PRELIMINARY PLAT REVIEW PUBLIC HEARING

For: Log Cabin Subdivision

Board of County Commissioners

Public Hearing of February 24, 2025

Figure 4: Preliminary Plat Layout

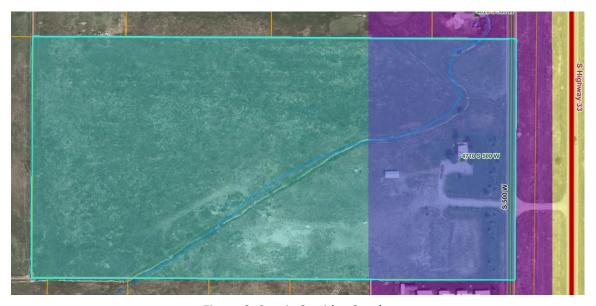
- 1. The plat be updated in the following ways:
 - a. A plat note should indicate that both lots will be accessed from the interior driveway and no new access from 500 will be granted.
 - b. This application was NOT processed as a short plat and that note is to be removed.
 - c. A plat note that indicates: Any additional subdivision will trigger the need for fire suppression as it would result in 3 lots.
 - d. The wrong code is cited on page one of the plat under the survey narrative. Should reference the Land Development Code.
 - e. Add a plat note: All future development that is within the scenic corridor overlay will trigger the need for a scenic corridor review.
- 2. Address public works comments:
 - a. All interior roads will need to be brought up to/built to County Local Road Standards
